Road Safety Audit
Stage 1
For
WESTGATE VISION AREA
PUBLIC REALM/URBAN REGENERATION SCHEME
WESTGATE, DROGHEDA, CO LOUTH

Reference: RSM/MOB/081222/WESTGATE RSA1

Client	Louth County Council
Project Title	Westgate Vision Area Regeneration Scheme, Drogheda, Co Louth
Document Title	Stage 1 Road Safety Audit
Document Ref.	RSM/MOB/081222/WESTGATE RSA1
Status	FINAL

Figure 12: Proposed Narrow loading bay on Fair Street

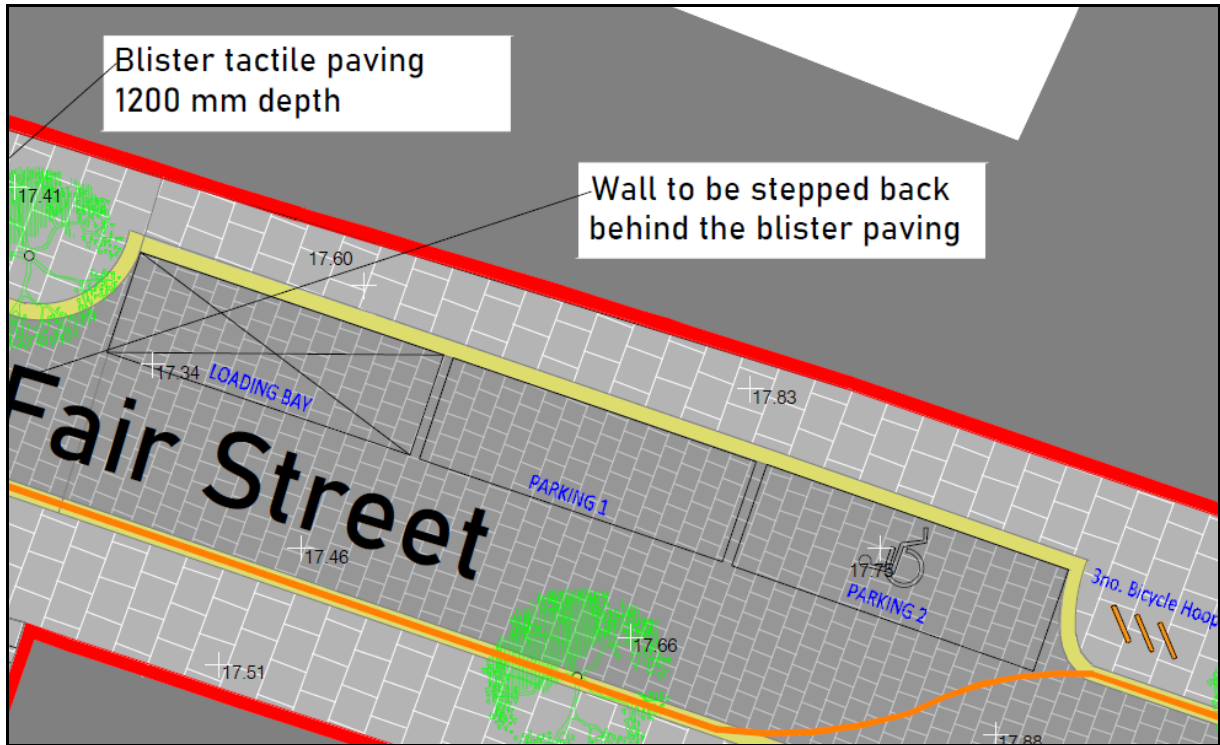
The cumulative parking demands for the Westgate area are unknown. Existing parking bays are being removed from a significant number of locations throughout the site, e.g. along the southern boundary of Father Connolly Way, and to the south of the junction of George's Street and Fair Street, and the provision for replacement parking elsewhere within the area has not been shown on the proposed layout plans. New parking bays are shown at some locations, however the provision for replacement of parking meters on narrow footways adjacent to some of these proposed parking bays has not been shown. Obstructions on narrow footway may prevent safe movement for pedestrians, particularly those who are mobility impaired, and may force pedestrians to step out into the carriageway into the path of oncoming vehicles.

space, with a buffer zone of 1m ideally provided adjacent to parallel parking bays where the adjacent traffic lane is shared by motorised vehicles and cyclists. The dimensions of all proposed parking bays and loading bays should also comply with the requirements of the Louth County Development Plan standards 2021-2027¹.

Figure 30: Landscaping in Visibility Splay to right at Fair St Car Park (one-way operation westbound)

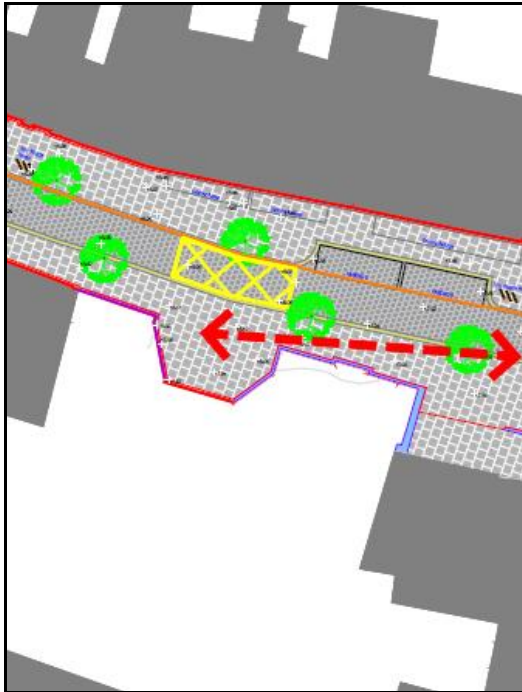
Proposed landscaping and trees were noted at locations where they may compromise safe traffic movement throughout the site for all vehicle sizes, and where they may obstruct visibility splays and intervisibility between pedestrians and approaching motorists. Landscaping has also been provided immediately adjacent to or within vehicle circulation areas, where there is a greater risk of being struck by passing and turning vehicles. Trees and landscaping located adjacent to pedestrian routes can create hazards due to falling leaves and slippy conditions, with tree roots potentially also damaging pavements over time, and potentially presenting trip hazards. Tree canopies can also reduce the effectiveness of street lighting, which may lead to an increase in collision risks during the hours of darkness, and reduce conspicuity of VRUs. Vegetation on the nearside of West Street may also obstruct clear visibility of the primary signal head aspect on the nearside, and likewise on the Georges St southbound approach to the signals at the junction, as highlighted in figure 26.

Figure 32: Proposed Landscaping within Southern section of St Patrickswell Lane

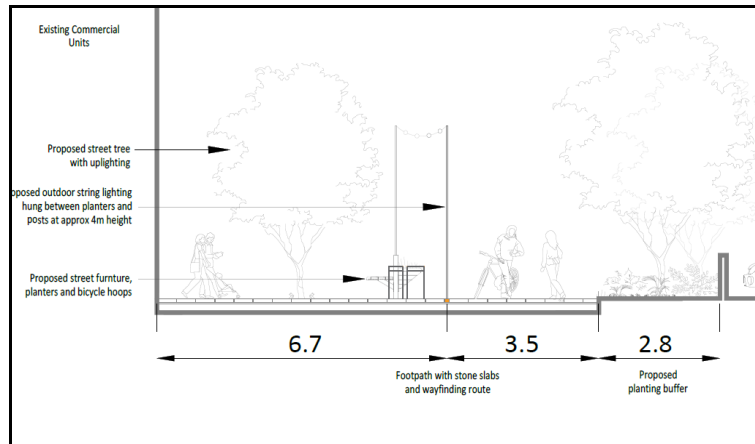
Landscaping has also been shown in the centre of pedestrian circulation area where tree pits may present hazards for some road users with walking aids, canes or heels, with sharp edges also shown on planters which are projecting into pedestrian circulating areas. Low overhanging

branches and vegetation in pedestrian circulation areas may also present overhead hazards to passing pedestrians and cyclists, including at eye height. Landscaping has also been shown at locations on the approaches to a number of the proposed pedestrian crossing points, where intervisibility will be obstructed, leading to an increased risk of pedestrian/vehicular conflict.

**Figure 51: Tree located with no clearance to traffic lane adjacent
On narrow footway (Section W-W, West Street)**

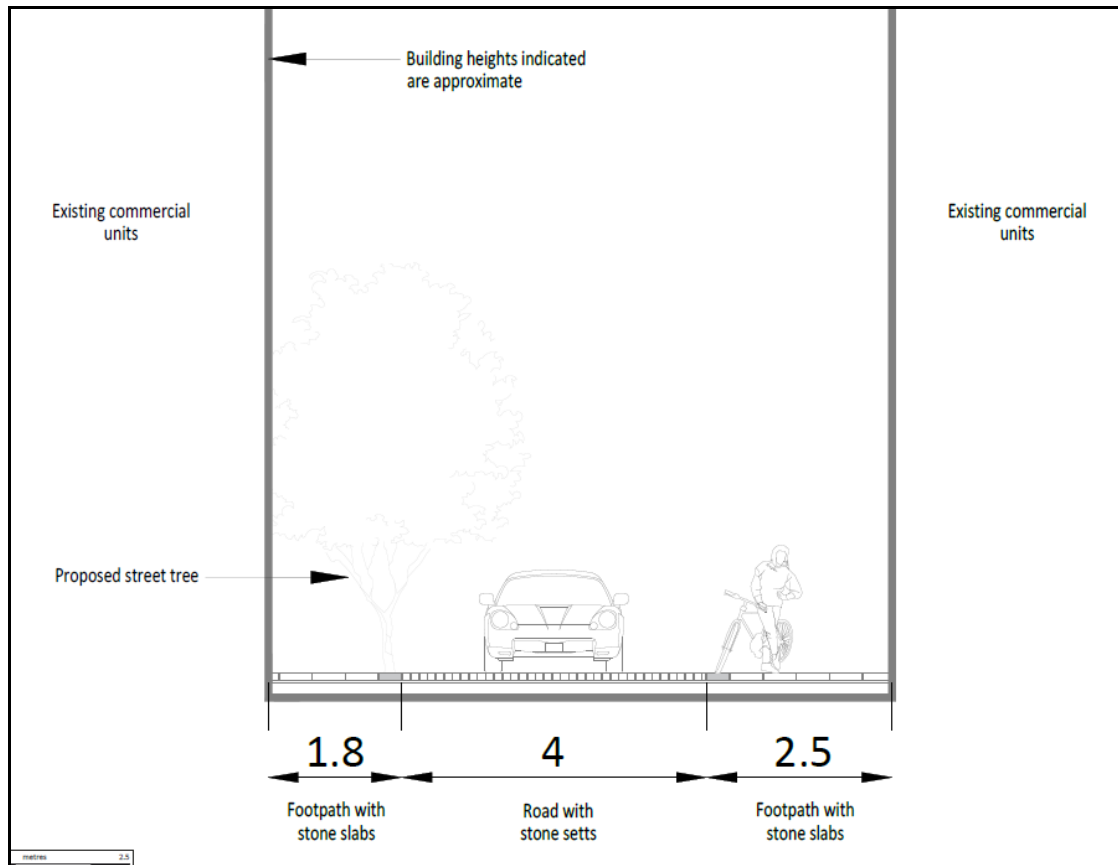
In areas where there is no traditional kerblines, a significant number of items of street furniture will be located in very close proximity to the edge of running lane, which presents an increased risk that the hazard will be struck. An example is shown in figure 51. The tree shown presents a wide canopy which will be struck by high sided vehicles (LGVs/HGVs) attempting to pass at this location.

Figures 57 & 58: Rights of way and details not shown at tie-in to junction opposite Scholes Lane

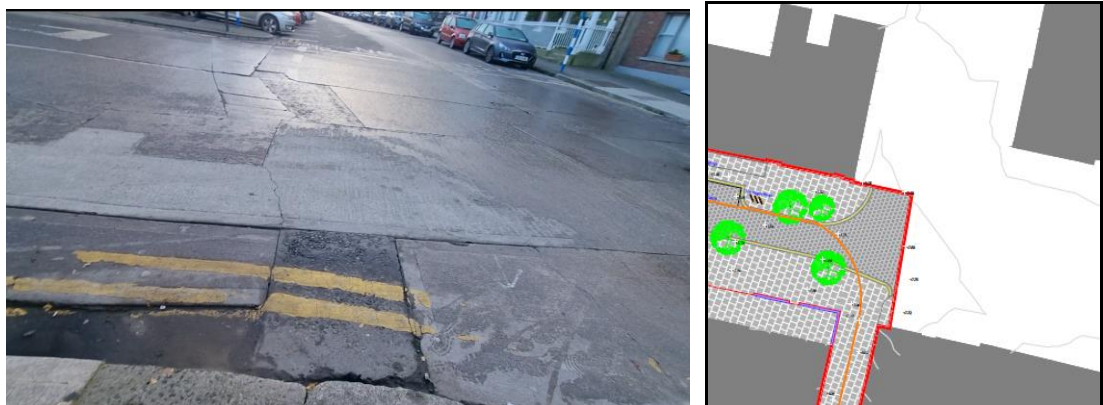
Visibility at a number of internal junctions may be compromised by building lines as outlined previously, and the risk of conflict at these locations may be increased by the lack of clear guidance on rights of way at some conflict points. Multiple conflicting turning movements will occur at some locations where rights of way not clear on the proposed layout, including at locations where conflict points are clearly lined and signed on the existing layout, but where the proposed design appears to have removed relevant road markings and signage, with an example shown in figure 56. The rights of way at some junction tie-ins have also not been shown, with an example shown in figure 57, which is the junction opposite Scholes Lane. Proposals for parking and landscaping at this location are likely to obstruct visibility to the right, although risks arising

Figure 62: Bus Stops obstructing visibility splays from junctions

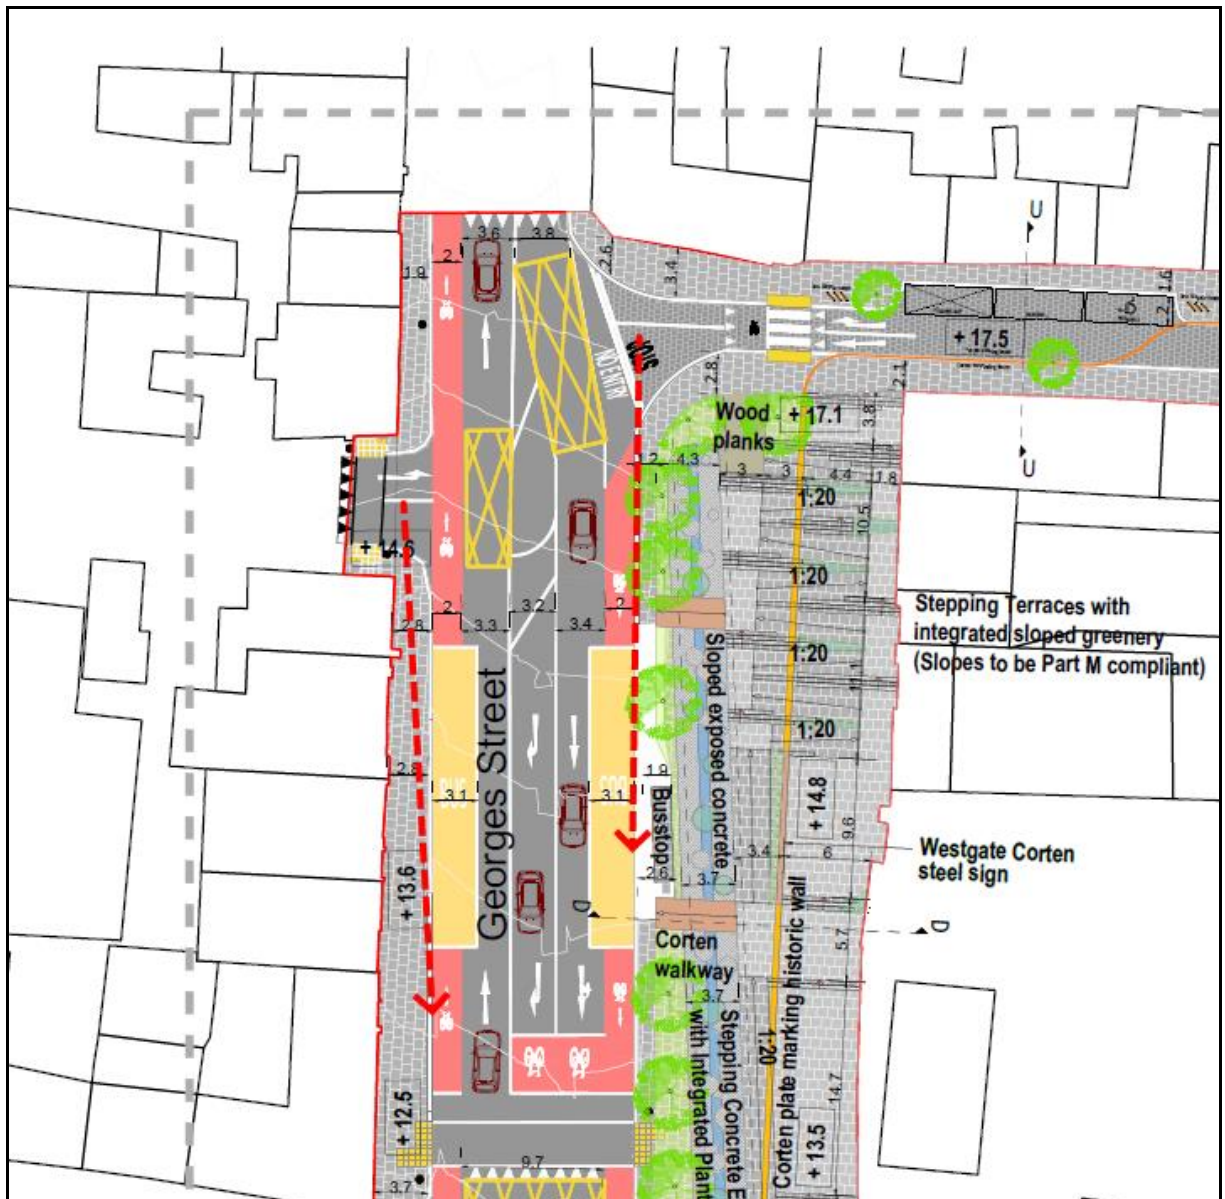
Visibility from the junctions to the North of the Bus Stops on George’s Street will be compromised by building lines, as outlined previously, and will be further reduced by the location of the reconfigured bus bays, as indicated on figure 62 (note visibility splays on all diagrams are approximate only).

Figure 63: Narrow Bus stop and parking bays on Dominic Street

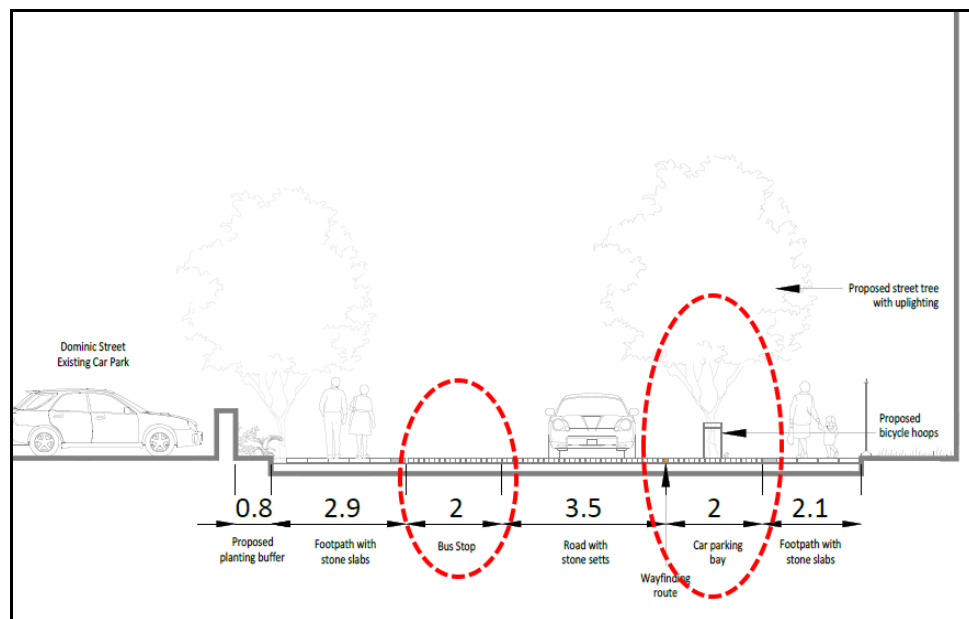
It is also unclear if there is sufficient space for the bus stop and any associated seating, shelter and dwell area at this location without obstructing space for passing pedestrians, particularly those who are mobility impaired, and there is no provision for Kassel kerbs to facilitate boarding and alighting by mobility impaired pedestrians. The kerb design at this location also presents poor channelisation and there are very sharp kerb radii both at the car park access/egress point and at the intersection of Father Connolly way and Dominic Street to the south. It was also noted that there is no continuity of pedestrian facilities into the car park at this location, and pedestrians wishing to access the car park will need to step into the carriageway on a narrow access point, due to the location of the wall.

Figure 64: Poor channelisation, Narrow Bus stop and reduced visibility at car park egress

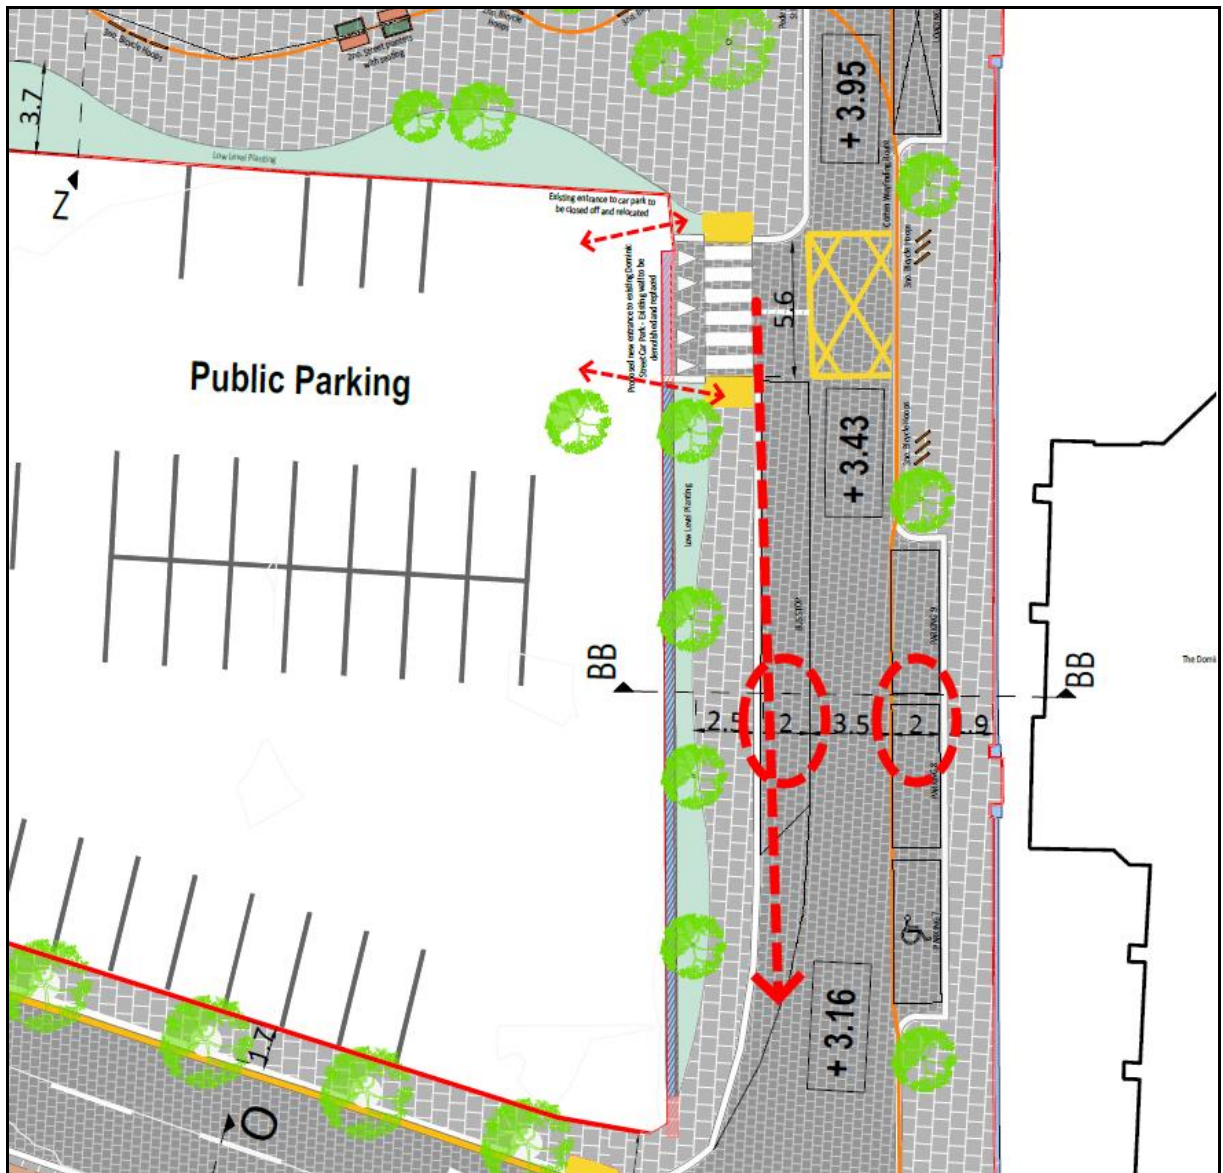
The provision for replacement of an existing bus stop on Father Connolly Way is not known, although a new bus stop will be provided on Dominic Street. Visibility to the right from the relocated egress point from the surface car park on Dominic Street will be restricted due to the location of the proposed bus bay, which has a narrow width. Buses will not have sufficient space to stop and wait safely in the carriageway without obstructing the path of passing vehicles, and buses or any other vehicles stopped at this location will obstruct clear visibility towards oncoming vehicles. Obstructions in visibility splays and poor channelisation can lead to an increased risk of pulling out type incidents and right-angled collisions, as well as rear shunt risks due to sudden breaking with vehicles slowing to turn in as well as slow moving vehicles turning out.

Figure 69: Discontinuous Cycle Lanes

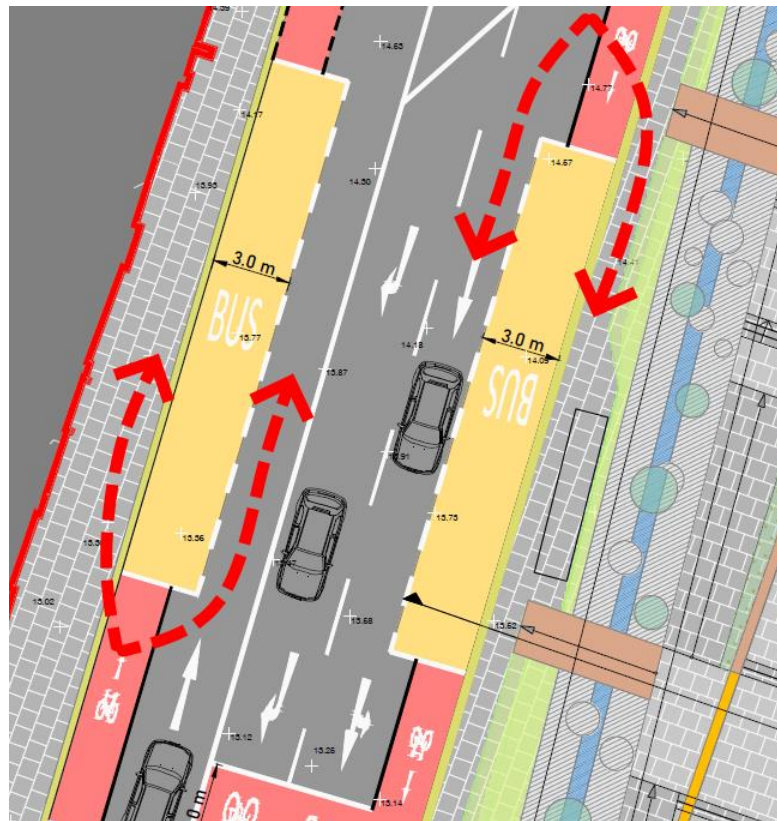
- There is no provision for safe continuity of the proposed cycling facilities through the bus stop area on both sides of George's Street, cyclists will be vulnerable at this location, and will need to enter the carriageway on a very narrow lane, presenting significantly increased risks of conflict with passing traffic, or alternatively pedestrians will need to mount the kerbs in potential conflict with pedestrians and passengers on the footway adjacent, including on the eastern side of the cross section, where the footway is narrow

Figure 70: Narrow two-way cycle track on Father Connolly Way

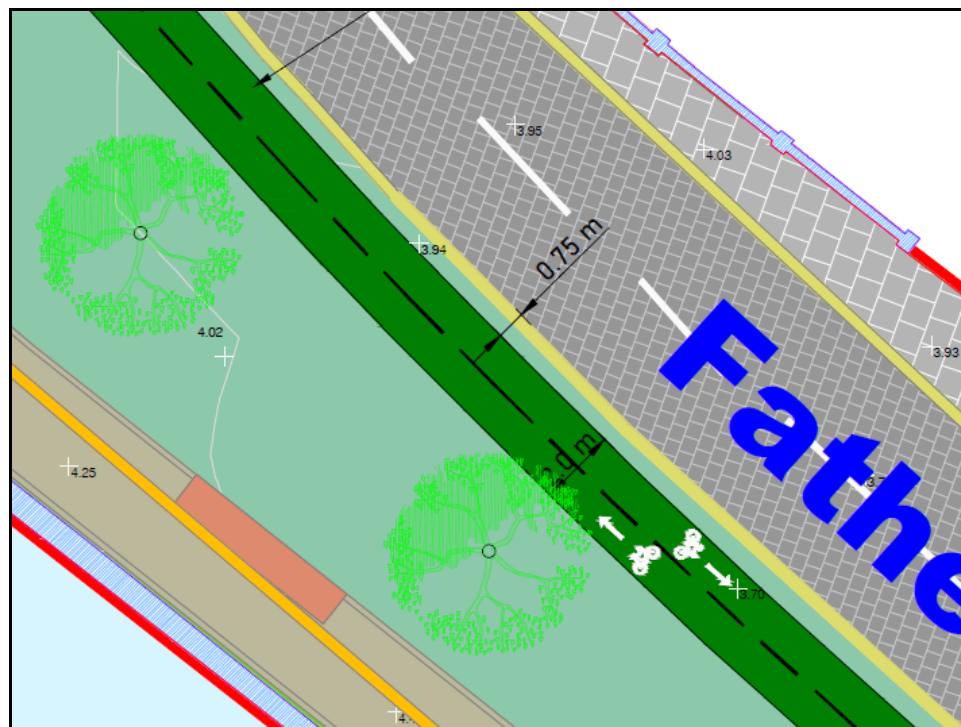
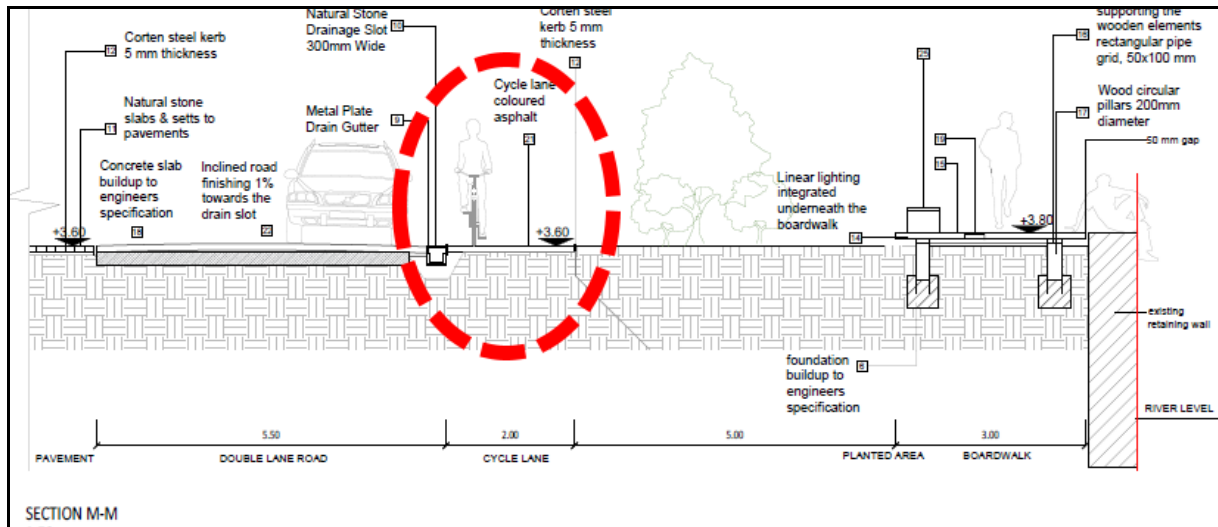
- The proposed two-way asphalt bicycle lane width along the Riverside on Father Connolly Way is too narrow for two-way use.
- The proposed two way cycle track intersects with the proposed walkway, with no provision for yield signs, dynamic visibility, or ladder and tramline tactile paving.
